MISSISSIPPI POWER & LIGHT COMPANY

July 20, 1984

SUBJECT: Grand Gulf Nuclear Station
Units 1 and 2
Docket Nos. 50-416 and 50-417
License No. NPF-13
File: 0260/L-860.0
Additional Information - TDI Engine
Inspection
AECM-84/0373

TABLE 1
Cylinder Head Baseline
Data for Flatness

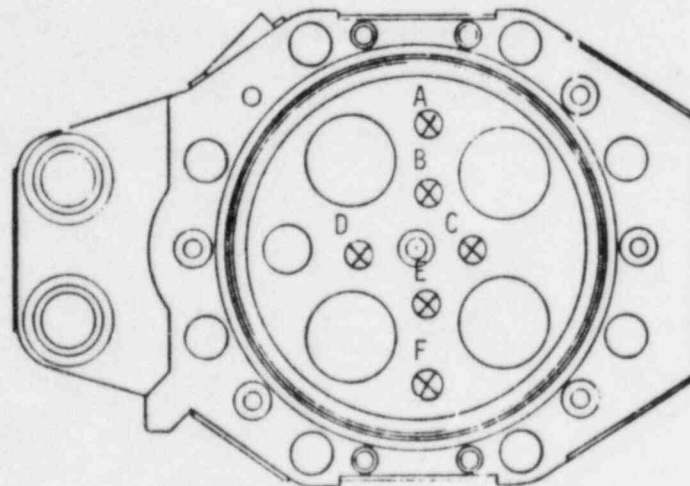
4. Documented results of measurements of the cylinder head fire deck surface flatness.

A straight edge and micrometer were utilized to obtain baseline information for the cylinder head fire deck profiles. Measurements were taken at six different locations on the fire deck. Readings varied from head to head as to the depth of the fire deck depression. Results of the measurements are shown in TABLE 1.

Changes in readings taken across the fire deck were due to the curvature of the fire deck and were consistent for all heads and did not indicate a problem with head warpage. These readings were taken for baseline data to be used in the future to determine if warpage of the heads may have occurred.
